Number	Description
1	Revised Bid Items; Revised or Added Plan Sheet Nos. 2, 11-12, 8001, 8003, 8030 & 8043; Amendment EBSx Download Required.
2	Postponed until October 26, 2021.
3	Revised Table of Contents; Revised Advertisement; Revised NTB No. 3576; Added NTB No. 3579; Revised Bid Items; Revised Progress Schedule; Revised or Added Plan Sheet Nos. 2, 4, 11-13, 81, 8001-8004 & 8022; Amendment EBSx Download Required.

BR-0070-02(015)/ 102624303000

Bridge Replacements on SR 6 through Marks (Bridge Nos. 31.3, 32.1, 33.2 & 33.5), known as Federal Aid Project No. BR-0070-02(015) / 102624303 in Quitman County.

ADDENDUM

SAND BLANKET TYPICAL SECTION AND DETAILS

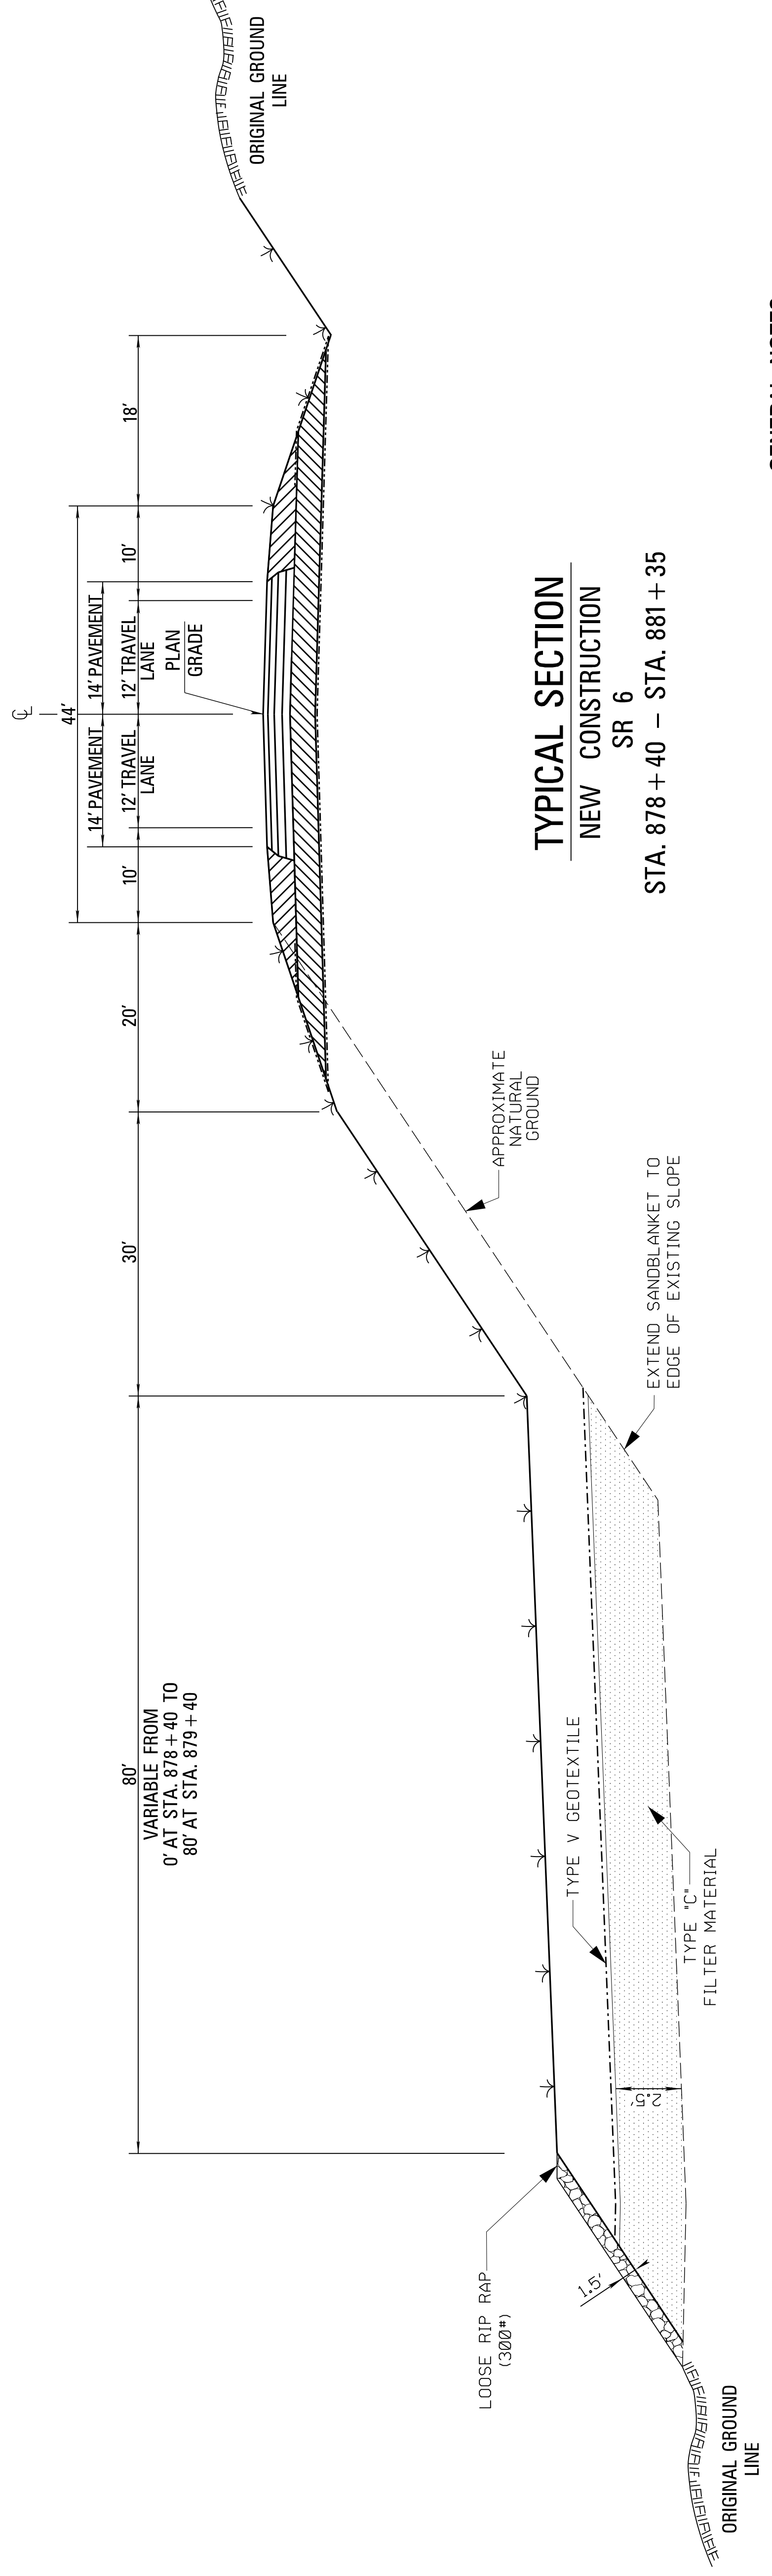
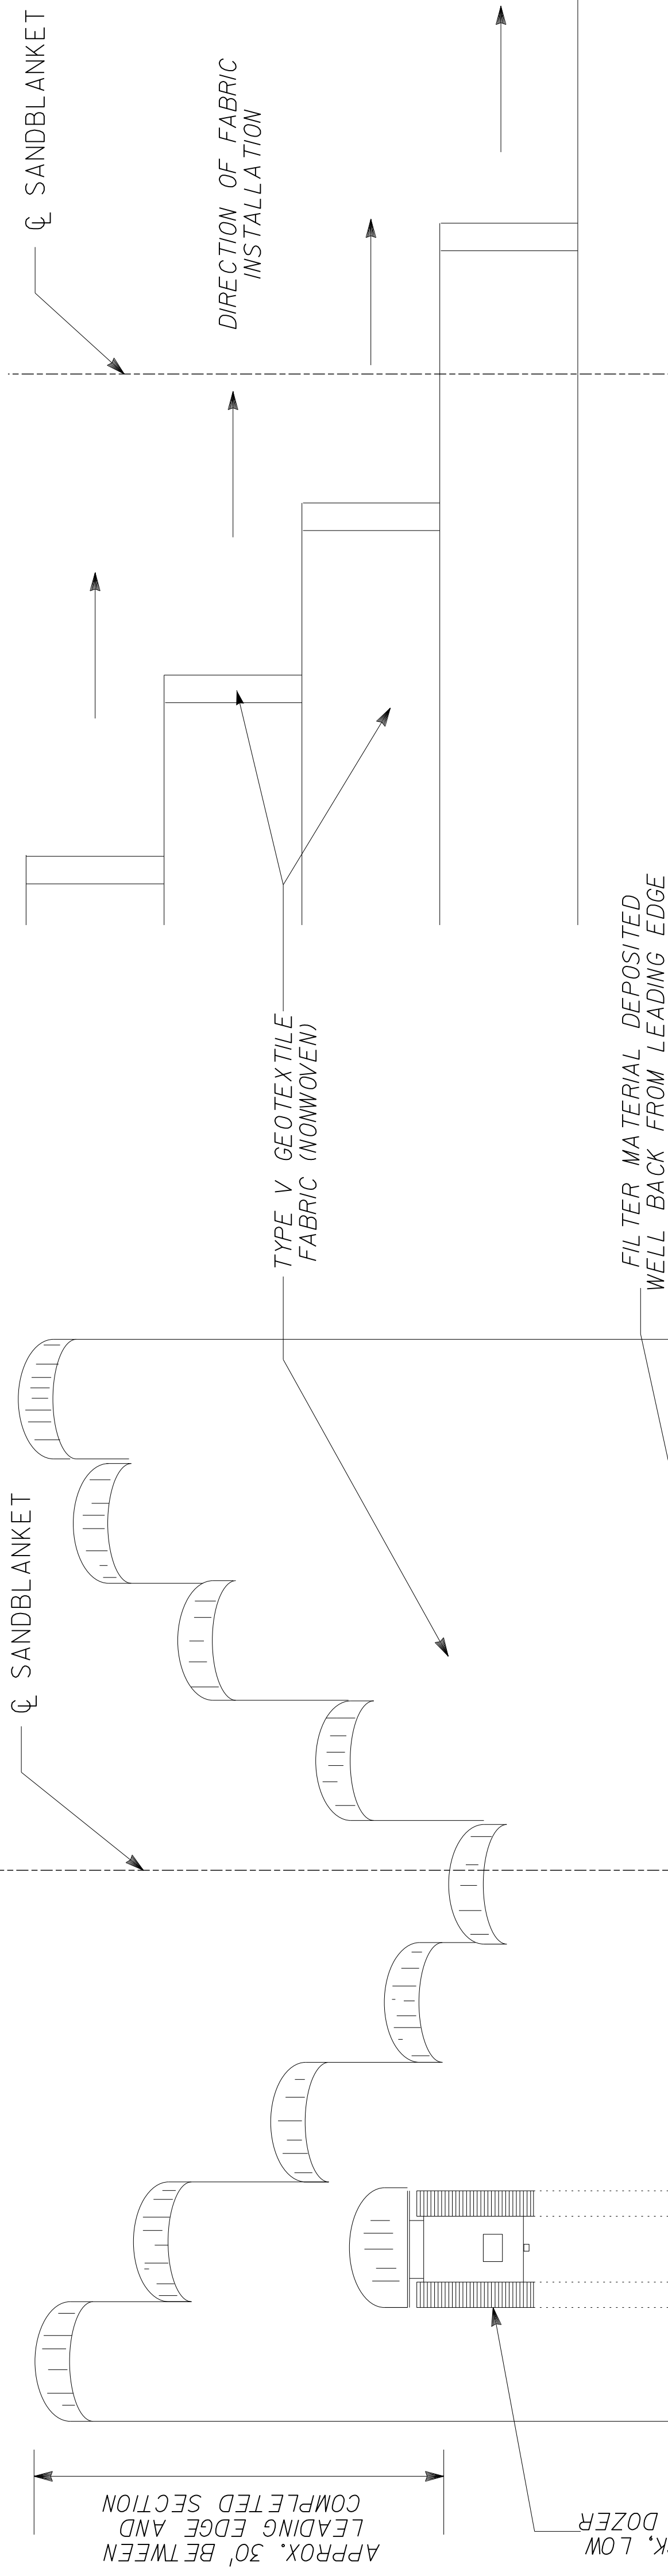
08/24/2021	ADDED PAY ITEM 907-207-A001	SB1
10/11/2021	ADDED SAND BLANKET QUANTITIES	SB1
09/17/2021	ADDED PAY ITEM 403-A003	SM
10/11/2021	ADDED SAND BLANKET QUANTITIES	SB1
10/11/2021	ADDED SAND BLANKET QUANTITIES	SB1
